**CALIFORNIA COASTAL COMMISSION**

## STAFF REPORT: REGULAR CALENDAR

**APPLICATION NUMBER:** 5-07-131

**PROJECT DESCRIPTION:** Remove and replace a private pier and gangway in same location, using two existing concrete piles and one new pile.

**EXISTING SITE PLAN**  
 SCALE 1"=20'

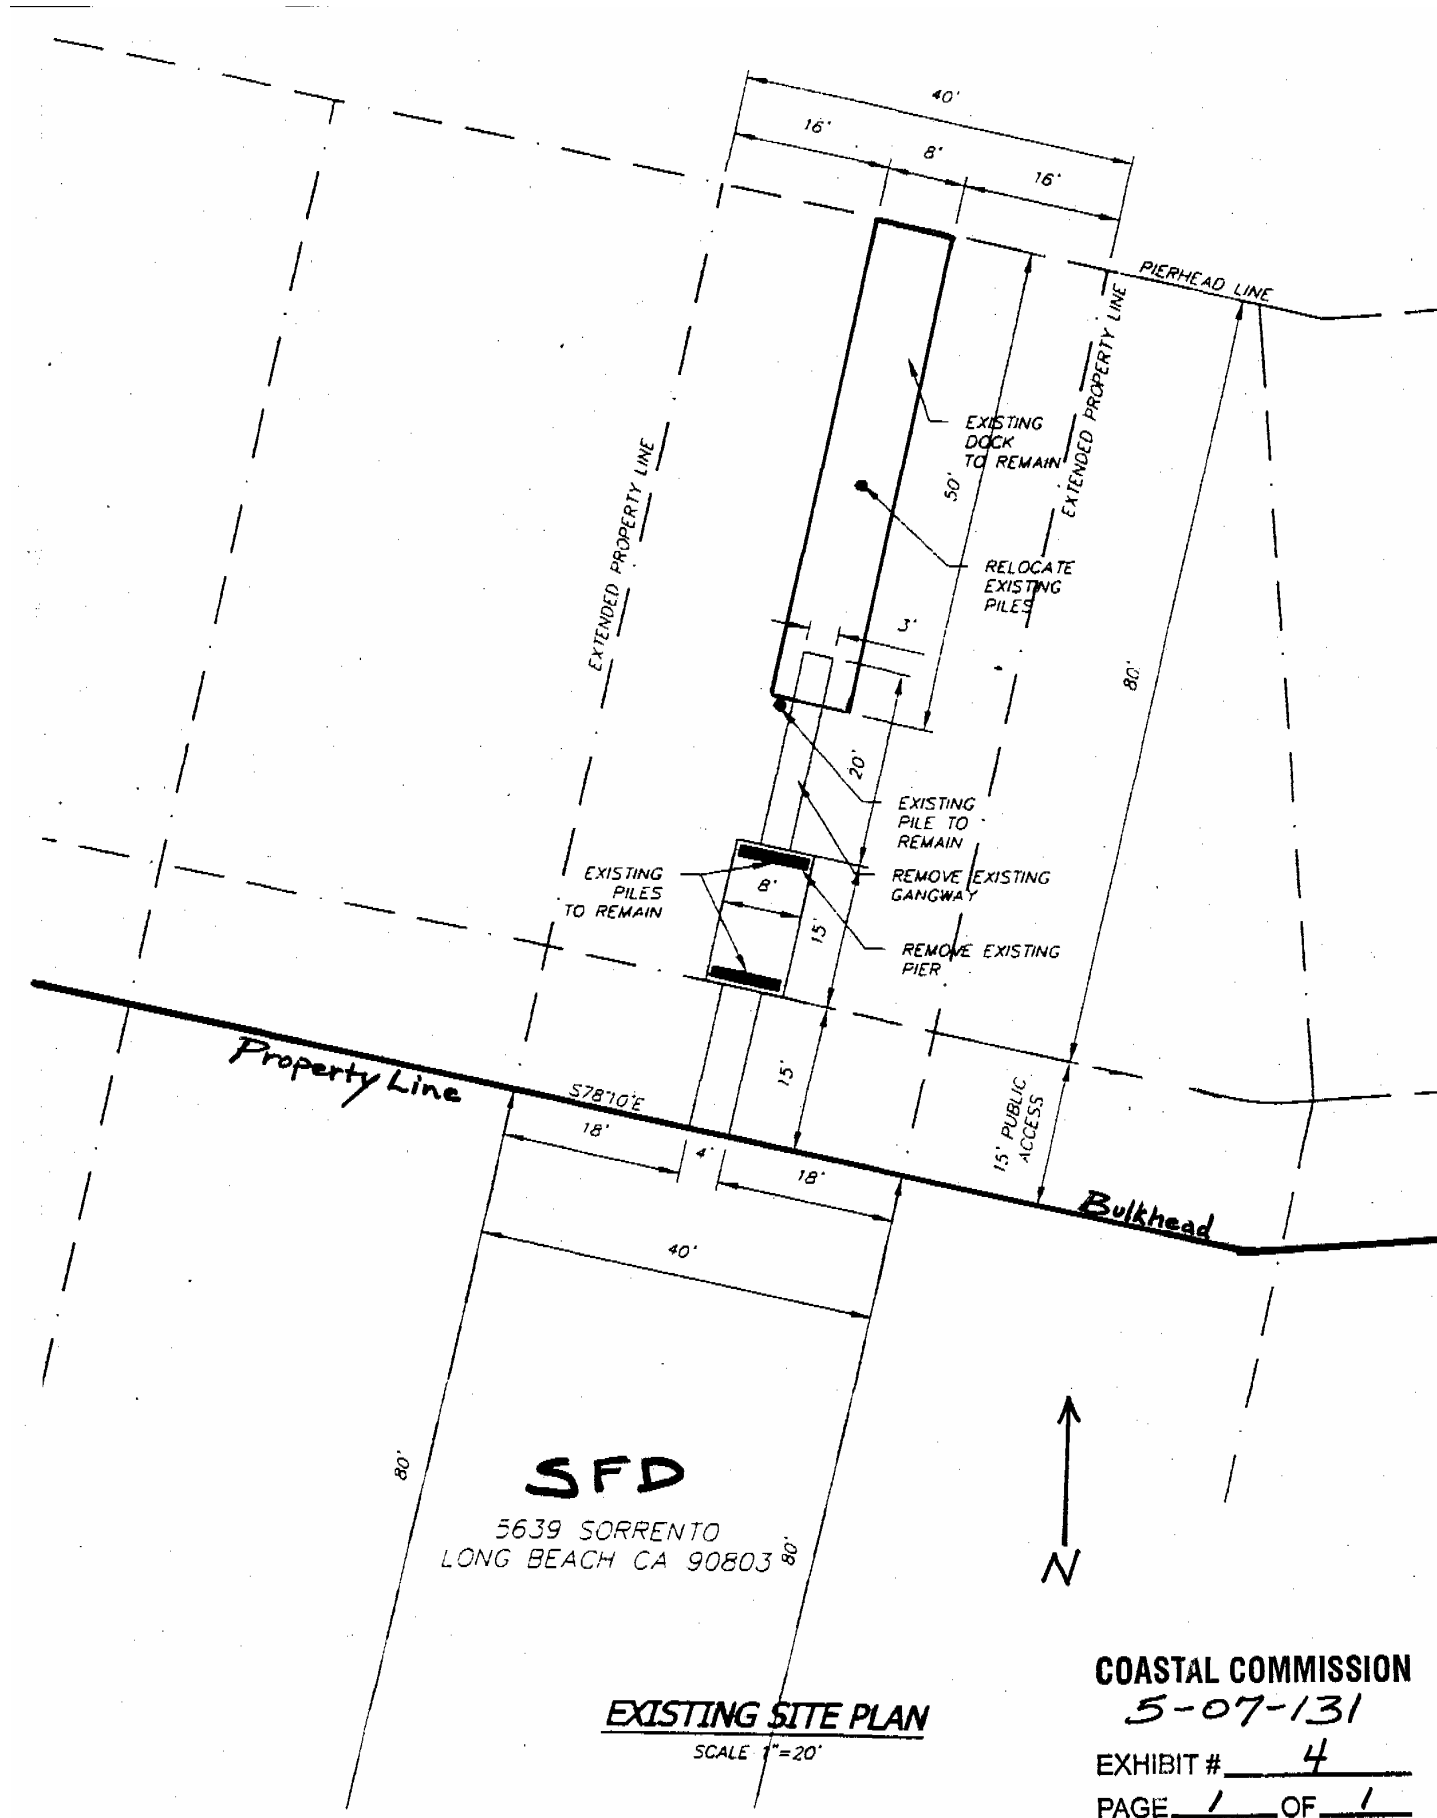
The proposed project involves the replacement of an existing private pier with a new one that is more than twice as large. The existing pier platform is 120 square feet and the proposed is 280 square feet in area (Exhibits #4&5). The proposed project is in Alamitos Bay (Naples Island) in southeast Long Beach, situated between an existing single-family residence and the City Pierhead Line (Exhibit #3). No eelgrass will be affected. The proposed pier (and existing floating dock) is associated with the applicant's adjacent single family home. The existing 8'x 50' floating dock at the end of the existing pier will remain, but the gangway will be replaced.

The applicant proposes to remove the existing thirty-foot long wooden pier and replace it with a larger structure in the same location using one new pile and the two existing concrete piles (Exhibit #4). The existing pier has an 8'x15' platform with a four-foot wide approach, which is generally consistent with the City's specifications for waterfront structures (Exhibit #7). The proposed new pier, however, has a 10'x 28' platform that is not consistent with the City's specifications for waterfront structures. In fact, the proposed pier platform is two times larger than the maximum 10'x 14' dimensions set forth by the City's specifications for waterfront structures (Exhibit #5). The proposed pier also has a four-foot wide approach to the pier platform, extending 16.5 feet from the existing seawall situated on the applicant's property line.

**PROPOSED SITE PLAN**

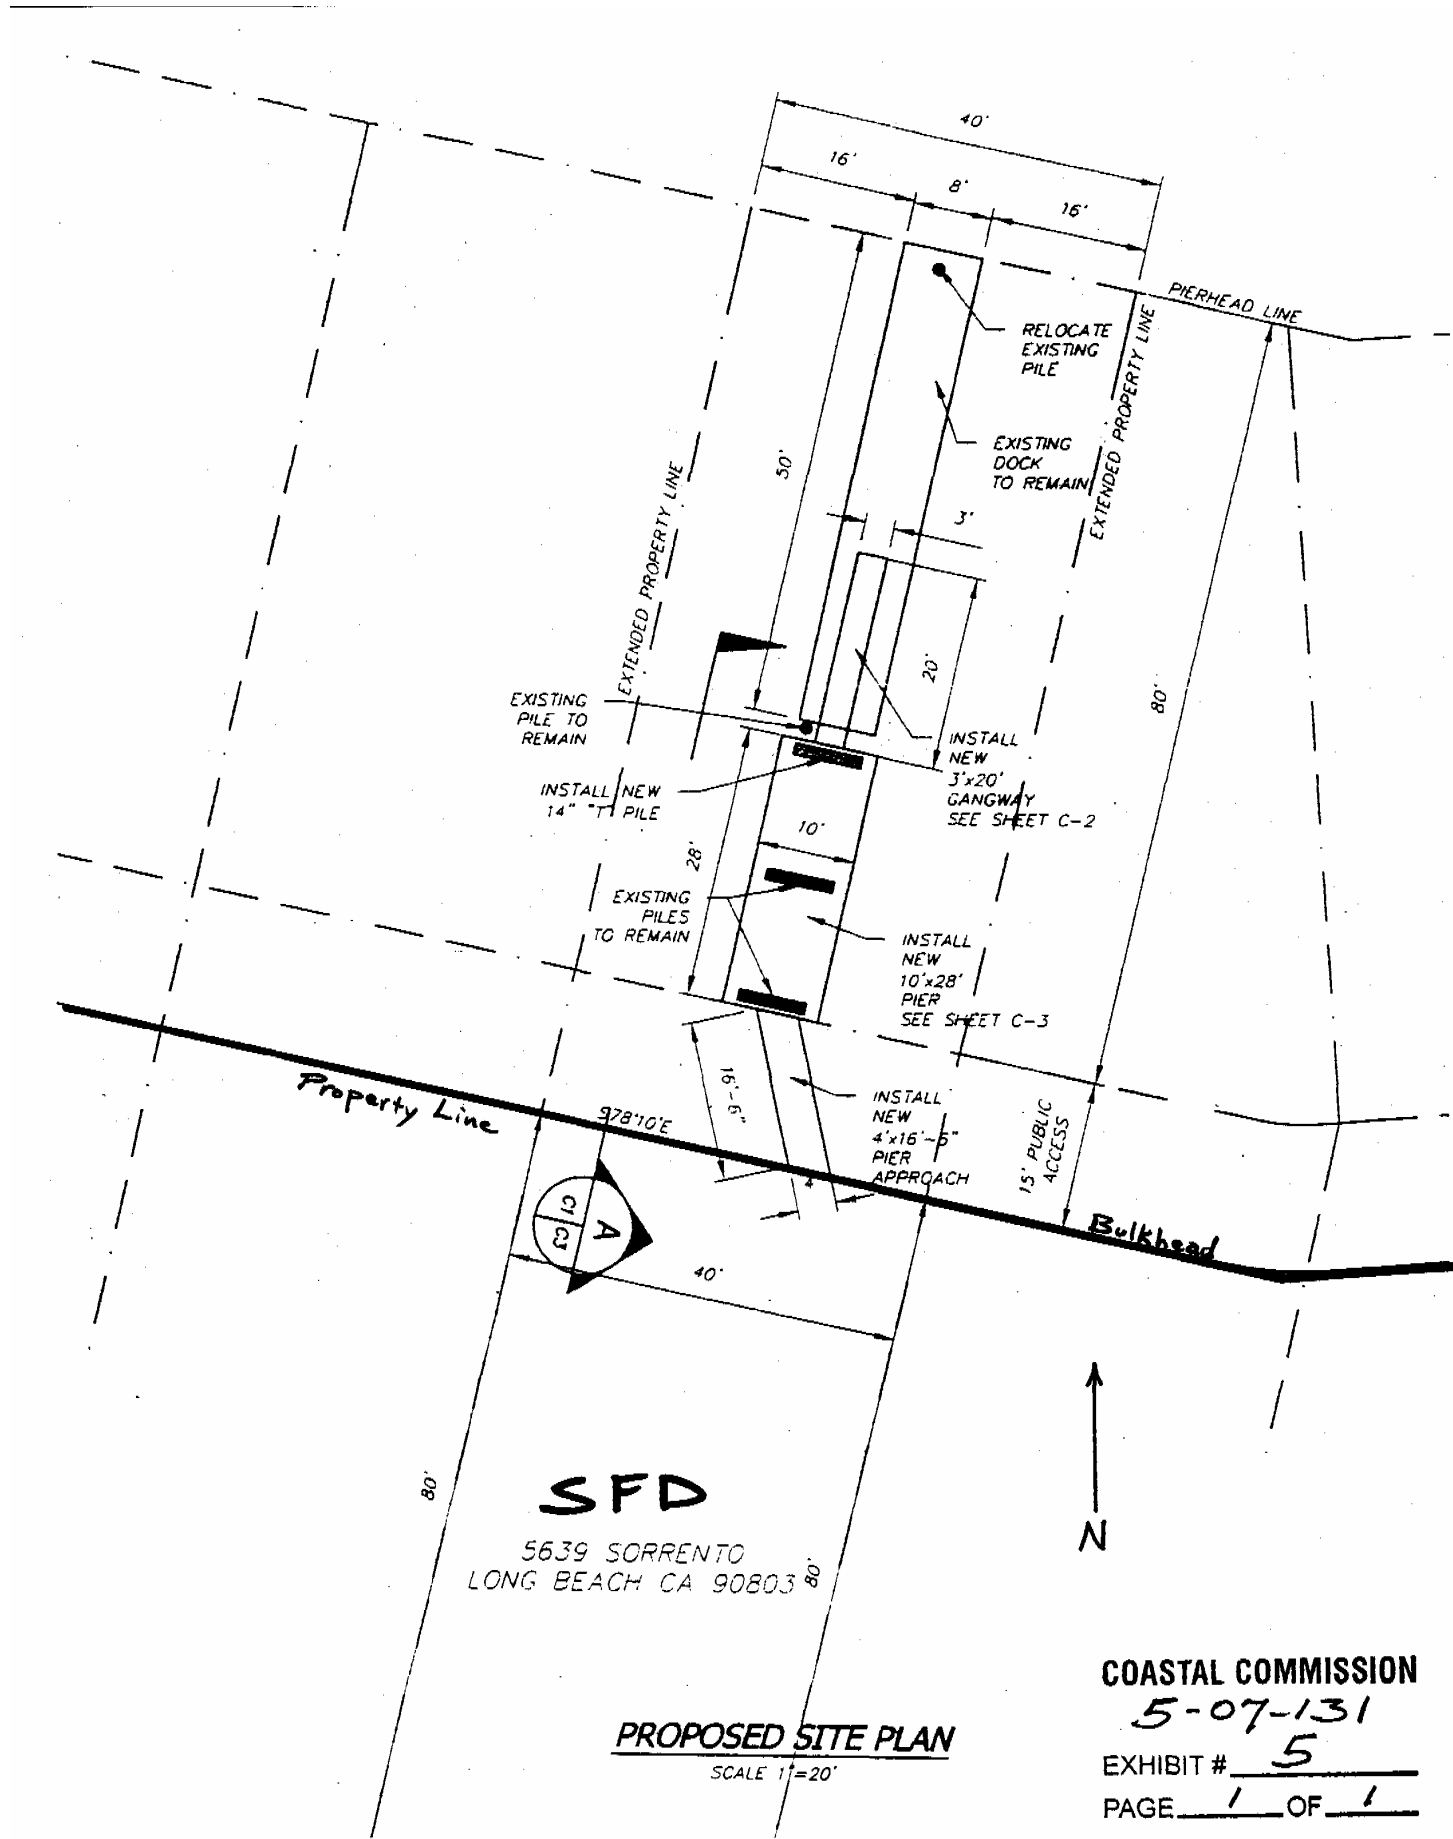
The issue of contention in this case is the large size of the proposed pier platform. Larger pier structures take up more of the bay's water area and create greater adverse effects on marine resources (e.g., shading and habitat displacement) than piers that conform with the City's specifications for waterfront structures (Exhibit #7). The applicant is requesting approval of a pier platform that would be two times larger than the maximum 10'x 14' dimensions set forth by the City's specifications for waterfront structures (Exhibit #7). The proposed pier would require the installation of a third support pile, while a pier that conforms with the City's specifications could be supported by the two existing piles (Exhibits #4&5).

As previously stated, the applicant's proposed extra large pier platform would require the placement of one new 14-inch diameter concrete pile, in addition to the two existing piles that support the existing pier (Exhibits #4&5). The proposed new pile constitutes fill in coastal waters, and is subject to the provisions of Section 30233(a) of the Coastal Act.

**PRIOR TO ISSUANCE OF THE COASTAL DEVELOPMENT PERMIT**, the applicant shall submit for the review and approval of the Executive Director, revised project plans that conform with the pier platform size limit (14'x 10' maximum) set forth in the City of Long Beach document entitled Plans & Specifications No. R-4858 (Revised) for the Construction of Waterfront Structures in the Long Beach Marina Area in the City of Long Beach, California, Office of the City Engineer, Long Beach, California, October 1994.

Only the two existing pier piles shall be used to support the new pier structure - no new piles are permitted. In addition, in order to enhance public access along the shoreline, the pier shall be designed to provide at least seven feet of vertical clearance between the lowest part of the pier approach deck and the beach located immediately seaward of the applicant's private property.

NEW DOCK, PIER & BROW--2005 SHEET  
D. BAKER--#5641 SORRENTO DR, LONG BEACH,

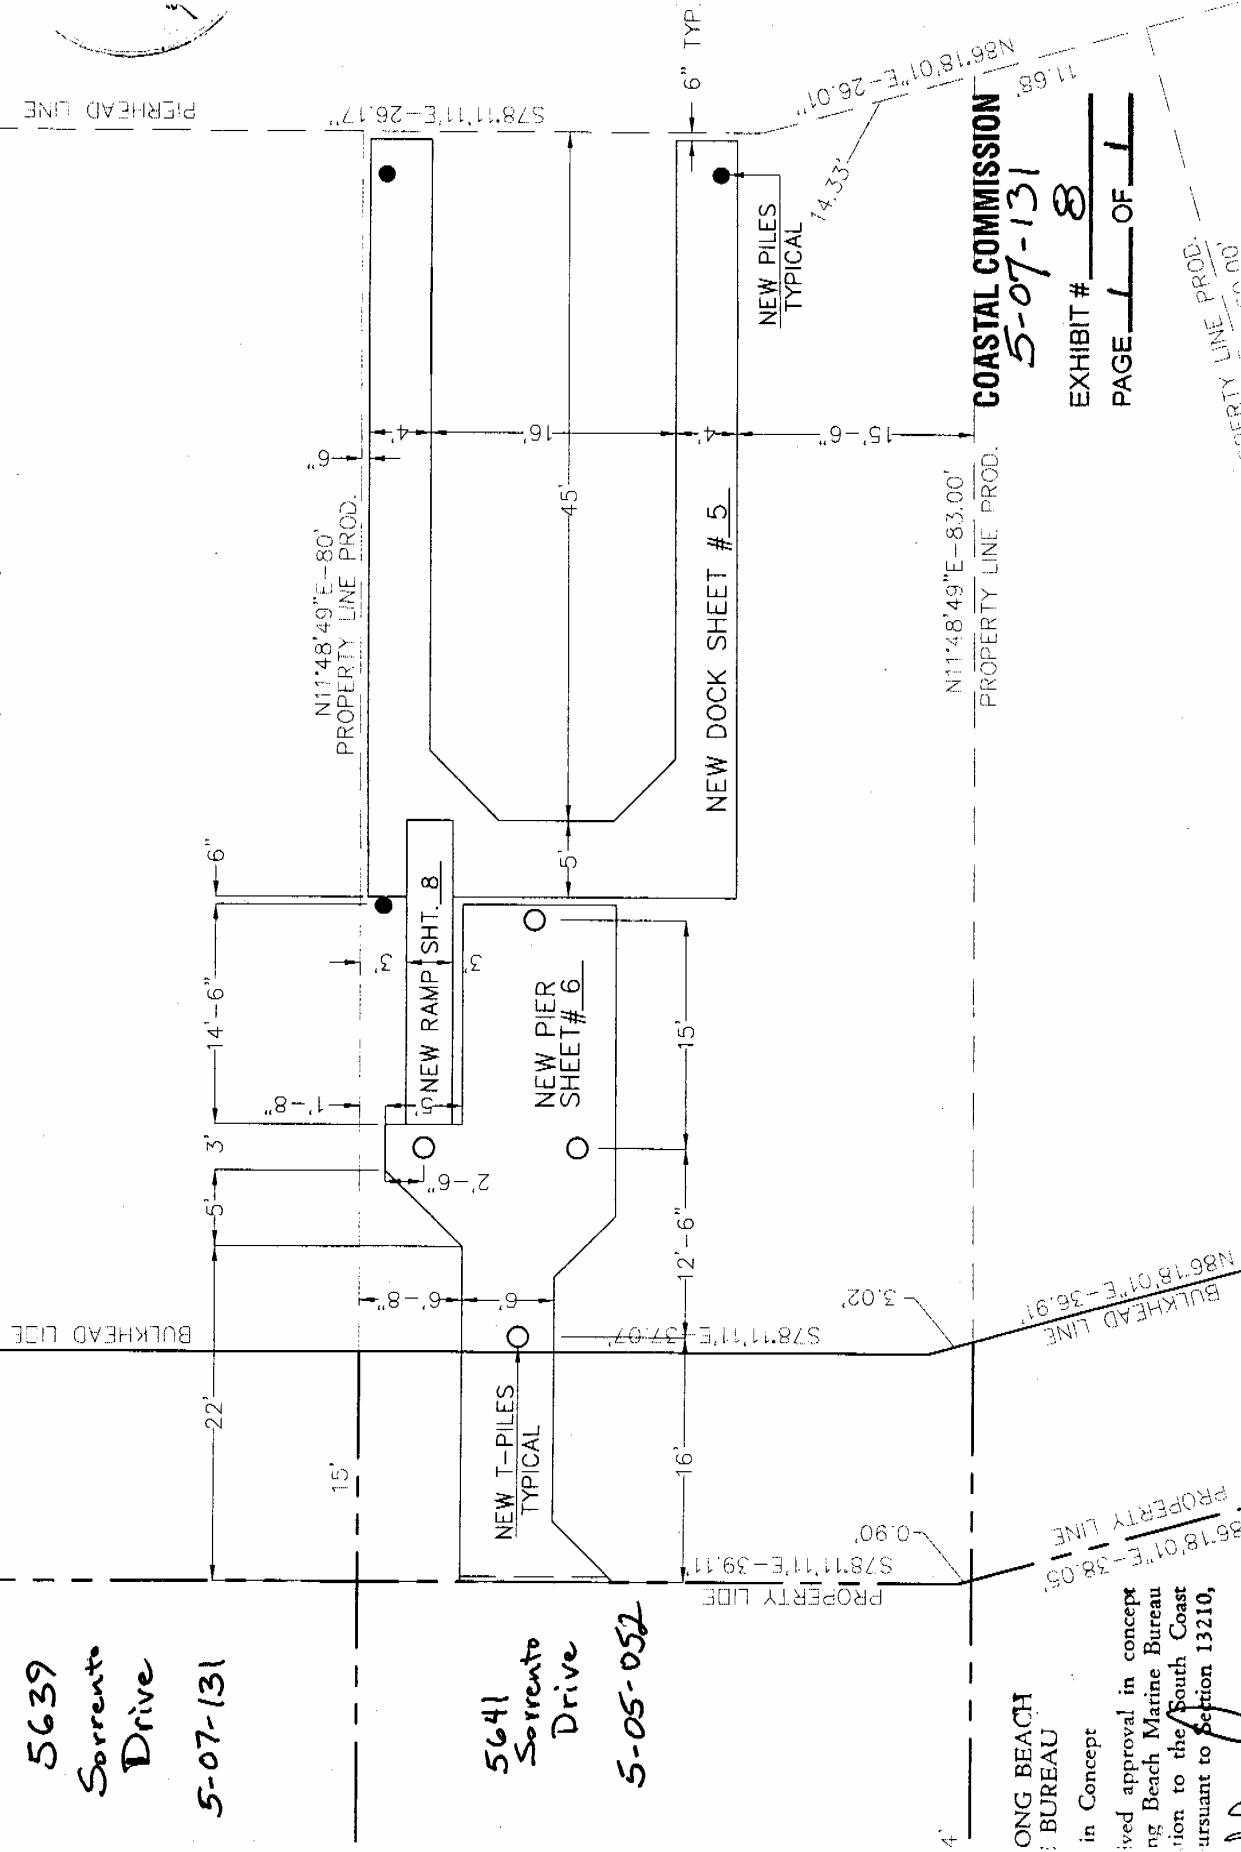
The applicant has also asserted that he is only asking for a pier similar in size to the one the Commission permitted his neighbor (Baker) to build next door in 2005 (Exhibit #8, Coastal Development Permit 5-05-052). The applicant's proposed pier is would cover approximately the same amount of bay bottom that Mr. Baker's irregularly-shaped pier covers, even though Mr. Baker did reduce the size of his pier from what had been proposed originally. Coastal Development Permit 5-05-052 (Baker) was approved as an Administrative Permit without Commission discussion of the precedential nature of the approval, and therefore that action should not be the precedent for pier size in Alamitos Bay. The Department of Fish and Game has not commented on either the applicant's proposed pier or Mr. Baker's pier.
